**STAFF REPORT:** 11/10/2021 MEEETING

**ADDRESS:** 8016 KERCHEVAL

**APPLICATION NO:** #21-7581

**SCOPE:** ERECT DECK BETWEEN EXISTING FRONT PORCHES; REPLACE WINDOW WITH DOOR; INSTALL ADA LIFT AT REAR PORCH; AND ERECT DUMPSTER ENCLOSURE IN PARKING LOT

Sheet Title :  
**EXTERIOR**  
**FRONT DECK**

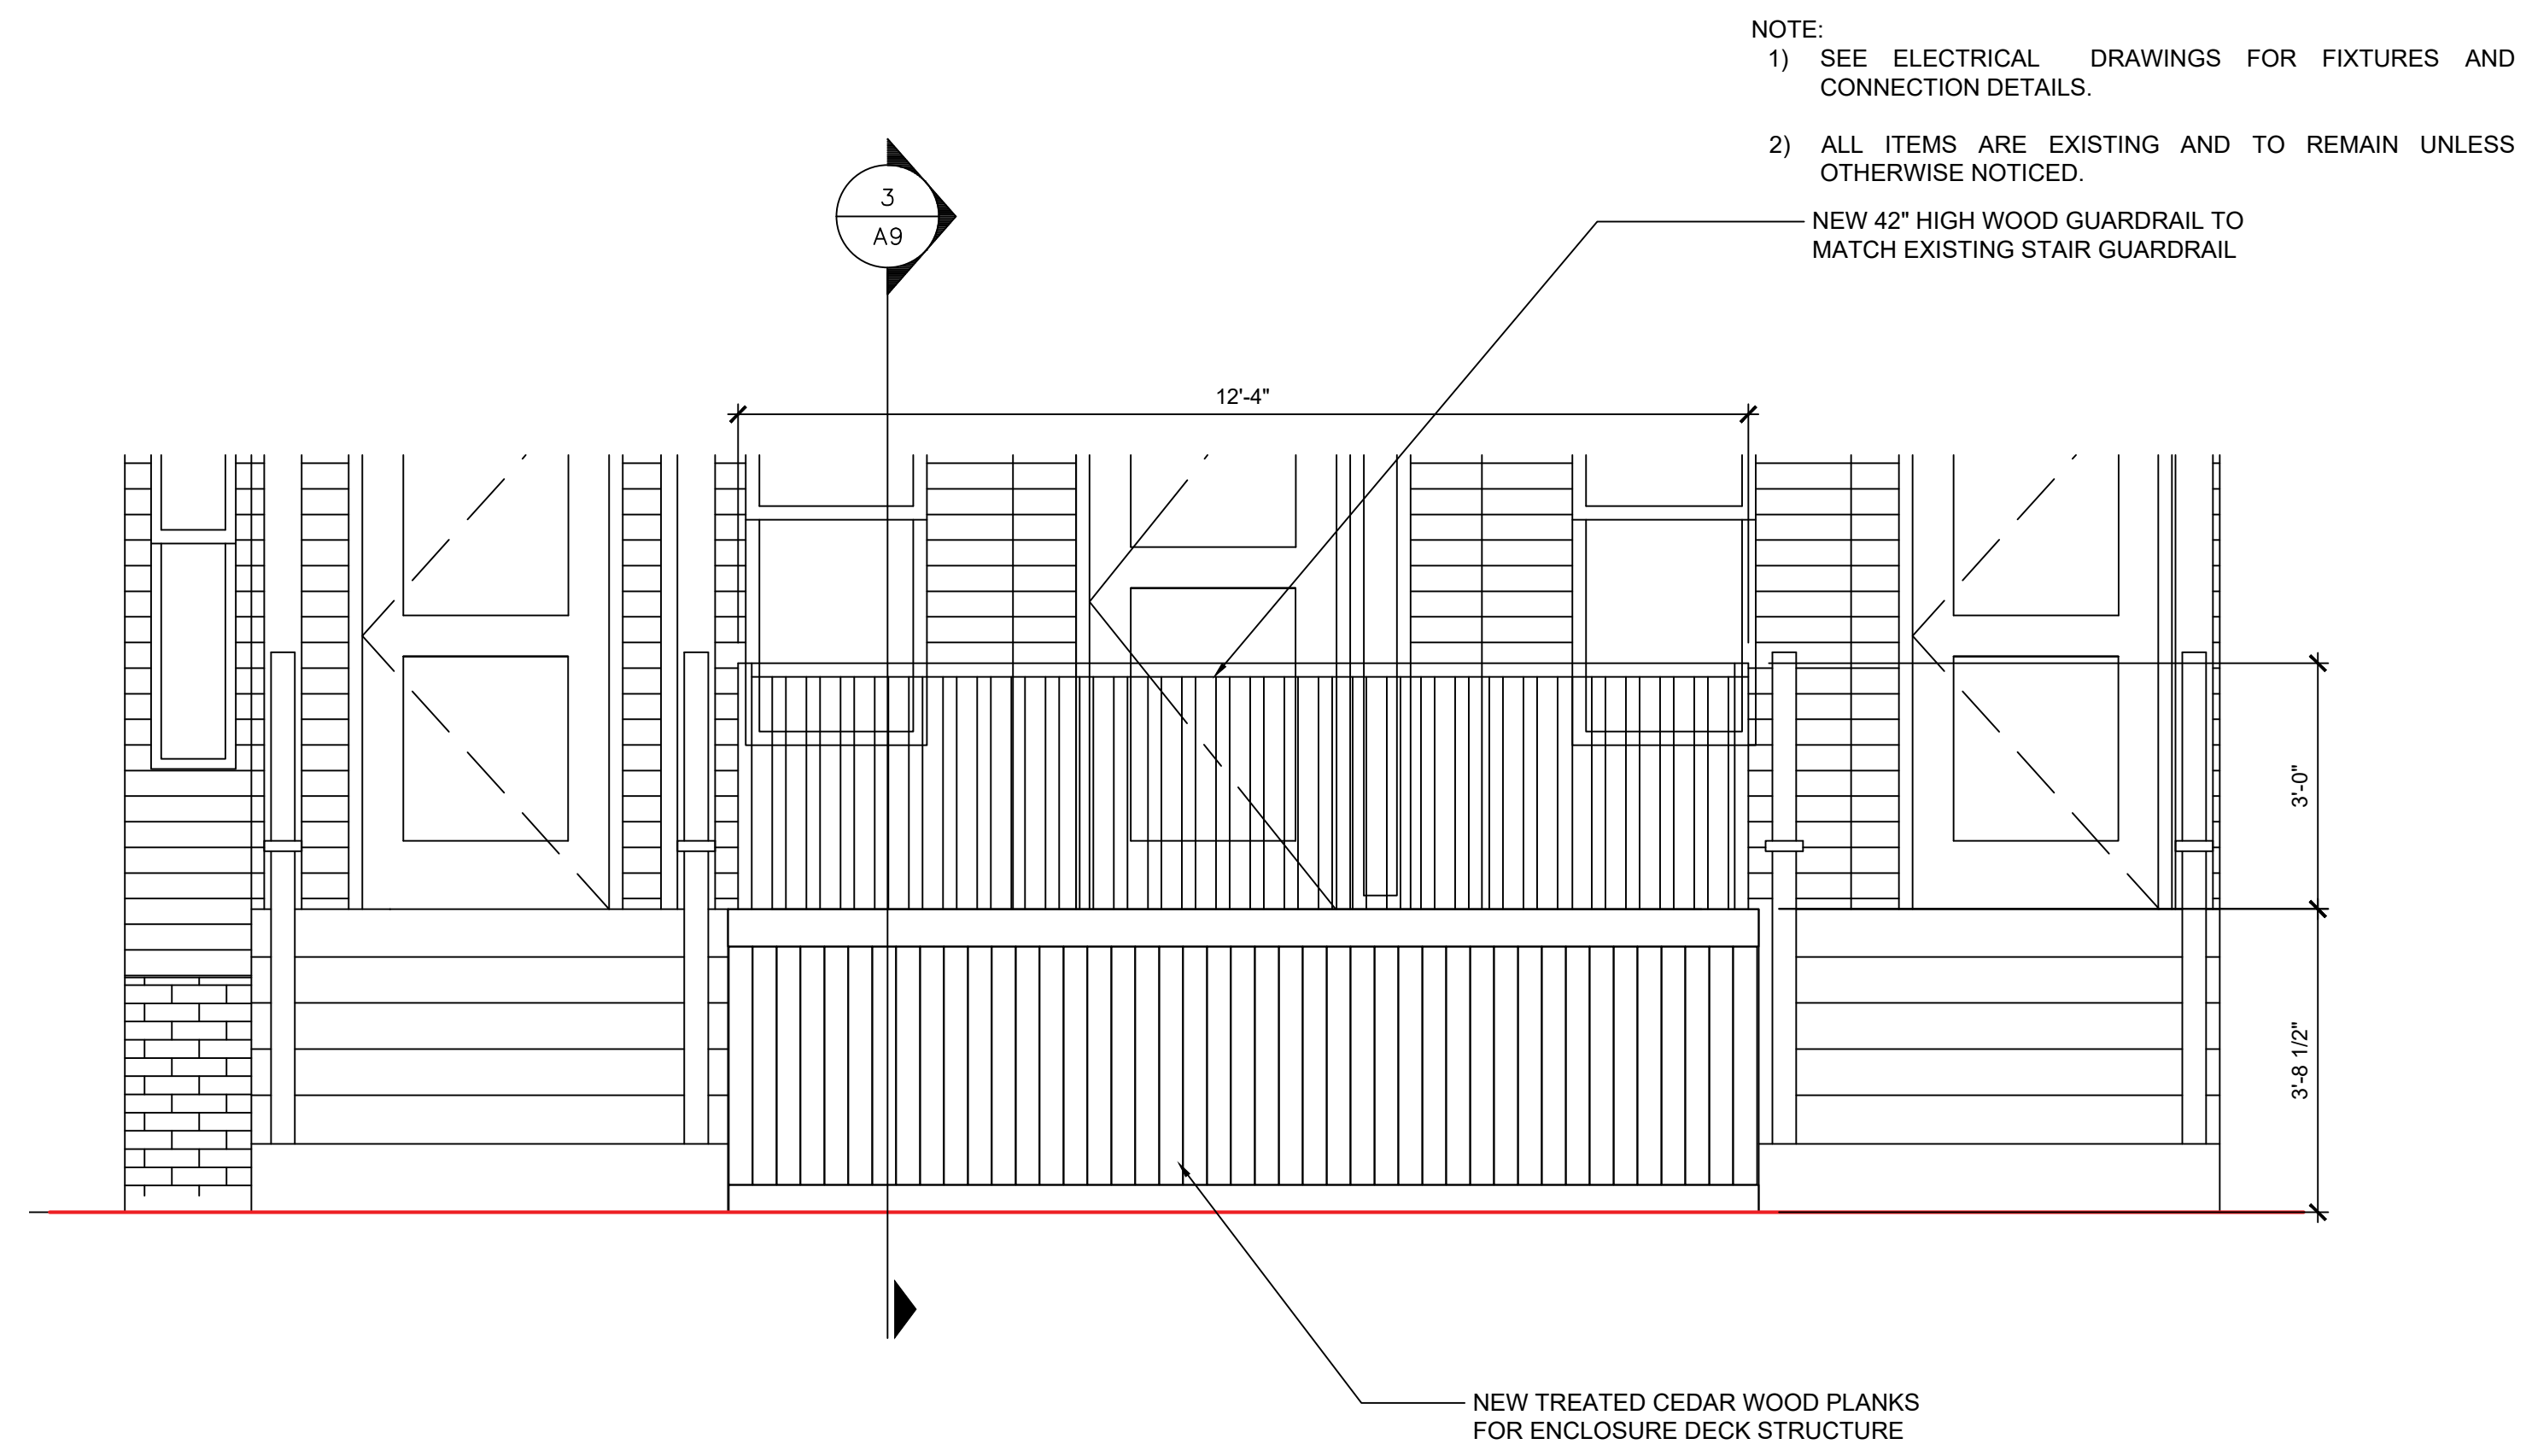
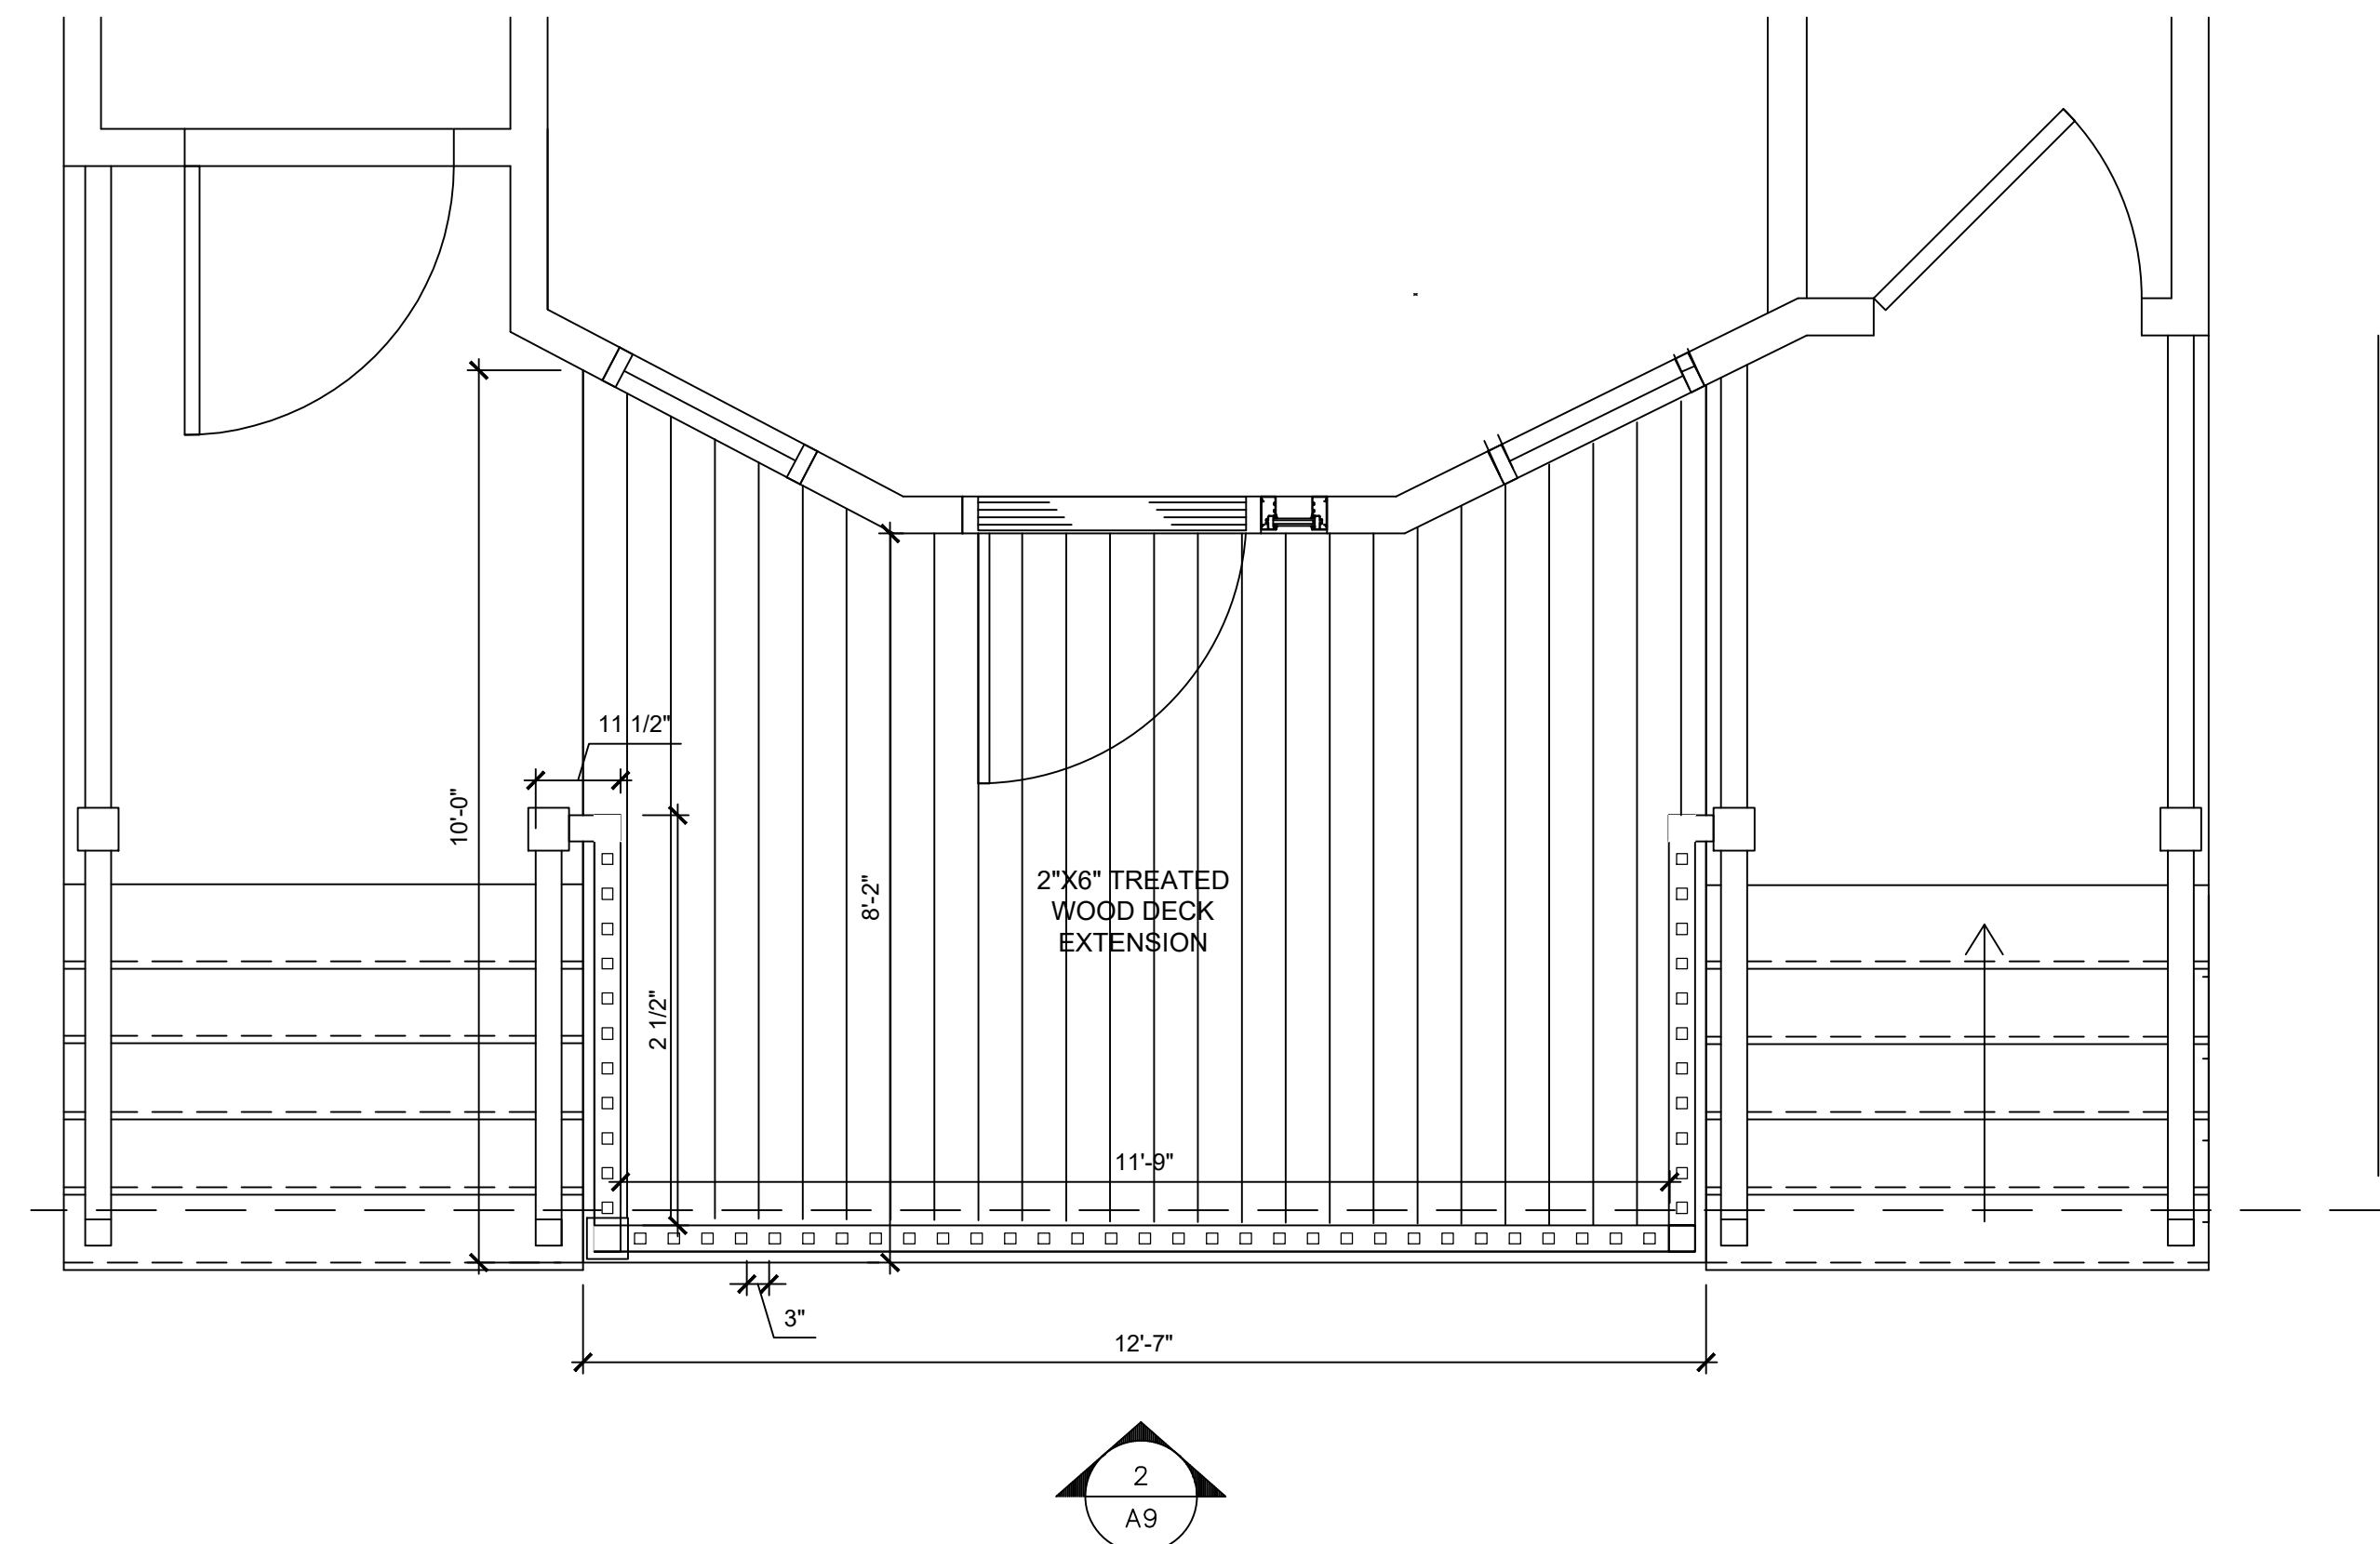
- It is staff's opinion that the front elevation window proposed for removal and replacement with a door and trim is a character-defining feature of the property. See the submitted proposed first-story floor plan. The new deck/outdoor patio space, if approved, will be accessible via the eastern door.

- As noted, the front elevation window proposed for removal and replacement with a door and trim is a highly-visible, significant character-defining feature of the property. Also, the addition of the door will detract from the original multi-family character of the building. It is therefore staff's opinion that this proposed scope item does not meet the Standards.
- The application does not specify the location of the proposed west elevation ductwork nor does it provide information re: the dimensions, material, etc, of the work item. A review of the floorplans indicate that the kitchen area is located towards the rear/southern 1/2 of the of the building. Staff would recommend that any exterior ductwork be painted a color which matches the **body** of the home, rather than the trim color.

- Remove the single, 1/1 “cottage-style” wood window and associated trim which is centrally located at the at projecting bay, first story. Lengthen the opening to allow for the installation of a new full glass, wood door with wood frame, painted to match existing black color. New door trim to match existing trim. The new door and trim will be painted black to match the existing trim. New lapped wood siding which matches the existing siding will be installed around the new door where needed to infill an gaps/openings. This siding will be painted grey to match the existing siding.

Staff recommends that the Commission **DENY** the issuance of a Certificate of Appropriateness for the following work items because they do not conform to the West Village Historic District’s Elements of Design and do not meet the Secretary of the Interior Standards for Rehabilitation, in particular, Standards #1) *A property shall be used for its historic purpose or be placed in a new use that requires minimal change to the defining characteristics of the building and its site and environment;* #2) *The historic character of a property shall be retained and preserved. The removal of historic materials or alteration of features and spaces that characterize a property shall be avoided;* #5) *Distinctive features, finishes, and construction techniques or examples of craftsmanship that characterize a property shall be preserved;* and #9) *New additions, exterior alterations, or related new construction shall not destroy historic materials that characterize the property. The new work shall be differentiated from the old and shall be compatible with the massing, size, scale, and architectural features to protect the historic integrity of the property and its environment:*

- The decking and steps at the two existing front porches shall be painted or stained a color which complements the building’s trim color. The new deck shall be painted or stained a color that corresponds with the color which will be applied to the deck and steps at the two existing front porches. The color of the railing at the new front deck shall match the railing

at the two existing front porches. The applicant shall provide a color palette for the decks to HDC staff for review and approval prior to the issuance of the project permit.
